NOTES: Route plan is Technically cleared subject to the following conditions,

SHEET 1 OF 4

PUNJAB STATE TRANSMISSION CORP. LTD		
SURVEYED BY	DRG.NO	SCALE:-1CM=50 MTR
DRAWN BY	PROPOSED ROUTE PLAN FOR CONNECTING 220 KV PGCIL LUDHIANA - DORAHA S/C ON D/C LINE WITH 220KV. LALTON KALAN - DHANDHARI KALAN S/C ON SC LINE. (LILO PORTION ONLY TL-1 TO TL) (ACSR ZEBRA 0.4)	
CHD. TLSC. CIRC. PTA

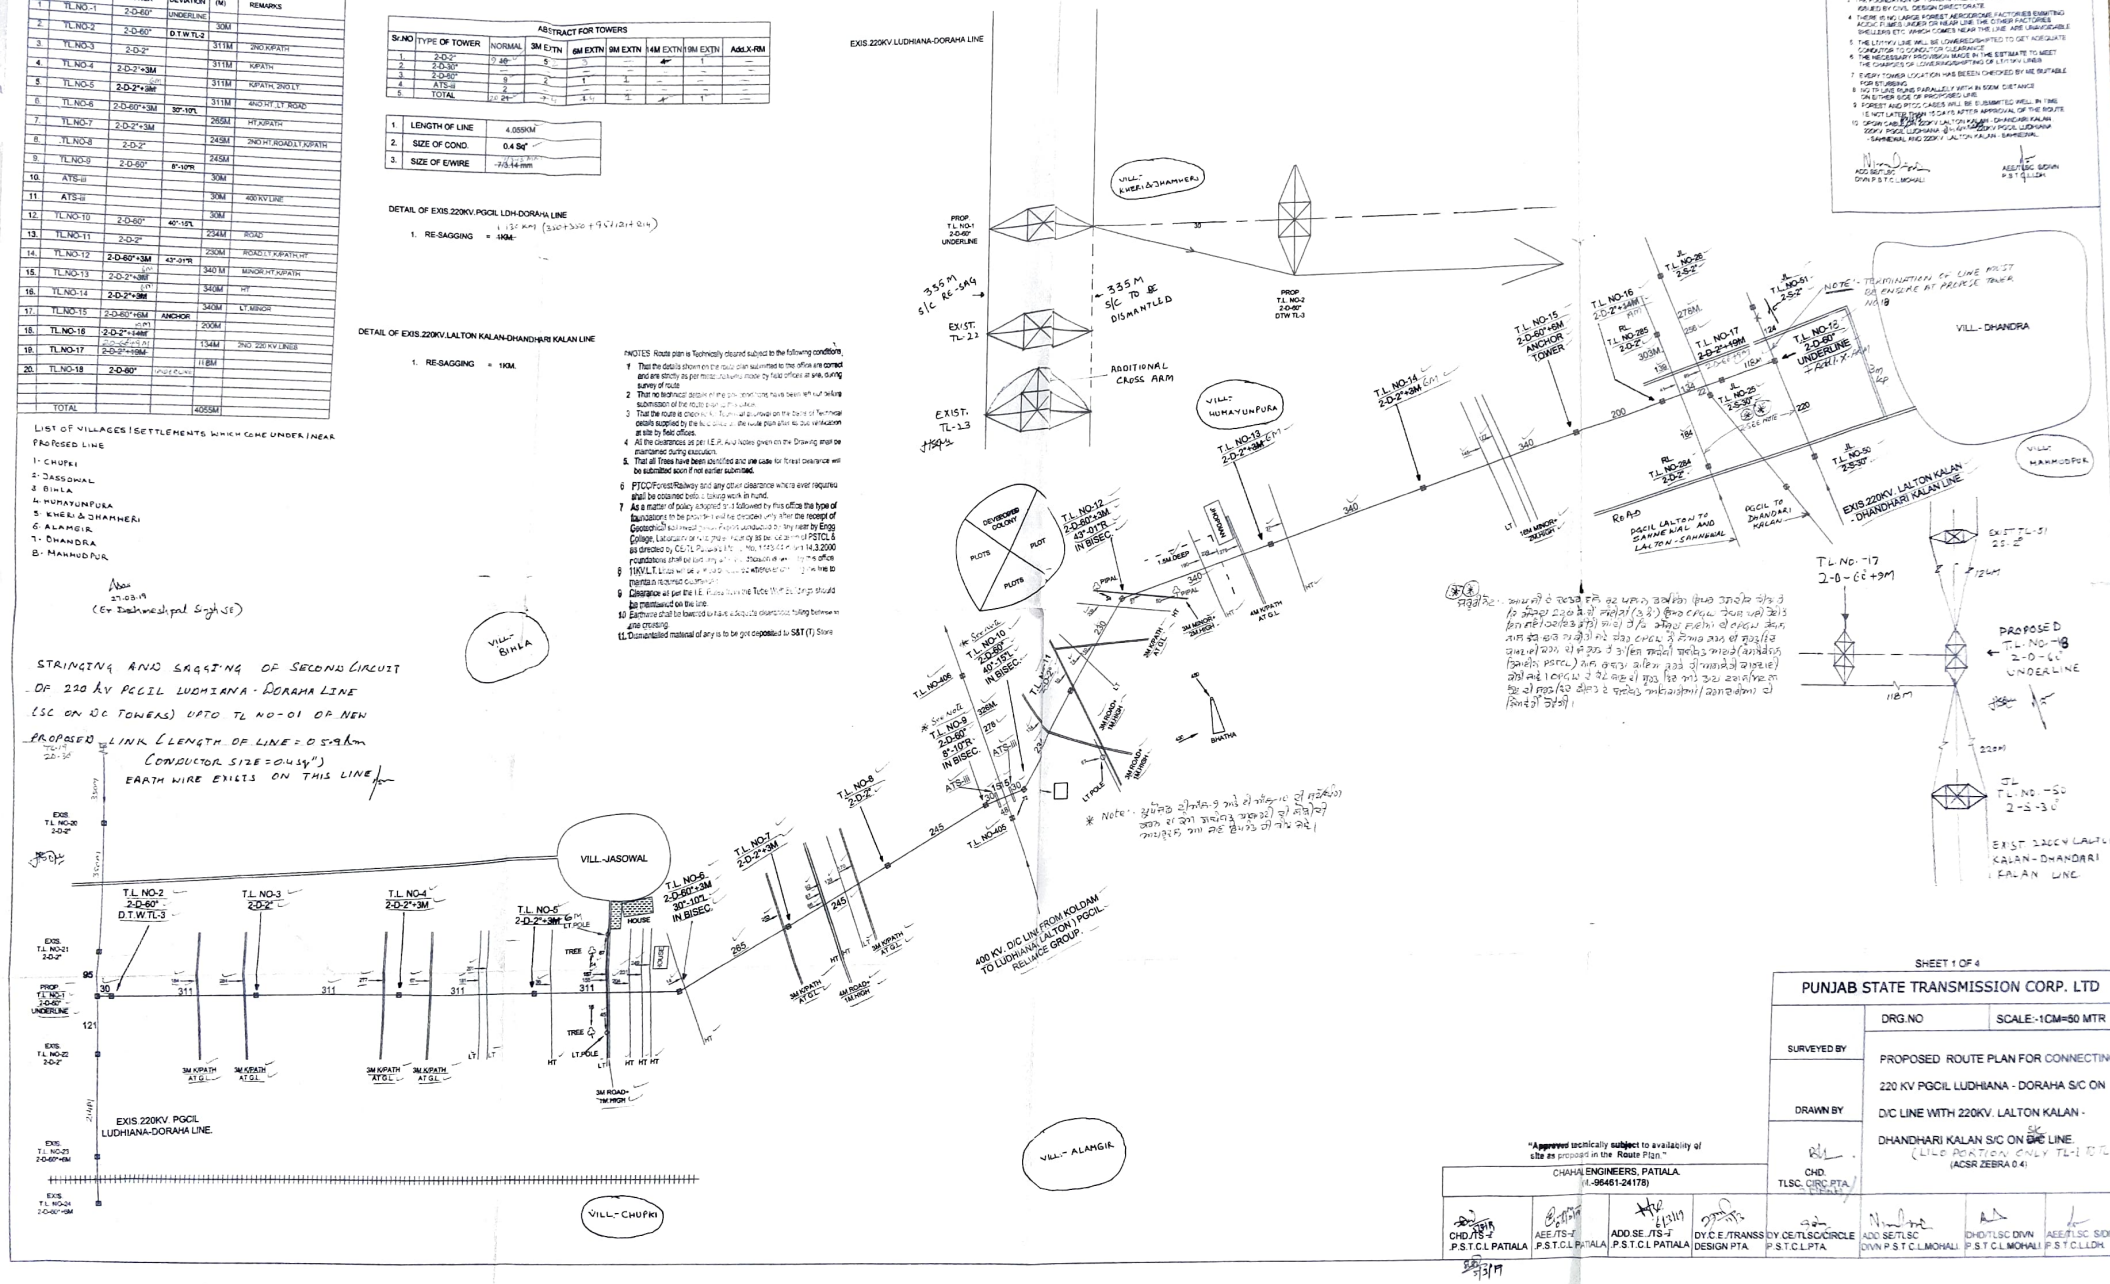
1. That the details shown on the route plan submitted to the office are correct and are strictly as per ground/site/work made by field officers at site during survey of route

2. That no technical details of the proposed lines have been left out before submission of the route plan for approval
3. That the route is chosen by the field officers on the basis of technical details supplied by the field officers. The route plan also is subject to verification at site by field officers.

4. All the clearances as per I.E.R. and Notes given on the Drawing shall be maintained during execution.
5. That all Trees have been identified and the case for forest clearance will be submitted soon if not earlier submitted.

6. PTCC/Forest/Railway and any other clearance where ever required shall be obtained before taking work in hand.
7. As a matter of policy adopted and followed by this office the type of foundations to be provided will be chosen only after the receipt of Geotechnical soil investigation reports conducted by any reputed Engg College, Laboratory or Private Agency as per clearance of PSTCL & as directed by CE/TL Punjab vide No. 1755-65 dt. 14.3.2000. foundations shall be laid only after obtaining the above clearance from the office

8. 11KV LT Lines will be provided on the extreme corner of the line to maintain required clearance.
9. Clearance as per the I.E. Rules for the Tube Well Pump sets should be maintained on the line.

10. Earthers shall be lowered to take adequate clearance, falling between the line crossing.
11. Dismantelled material of any is to be got deposited to S&T (T) Store

"Approved technically subject to availability of site as proposed in the Route Plan."
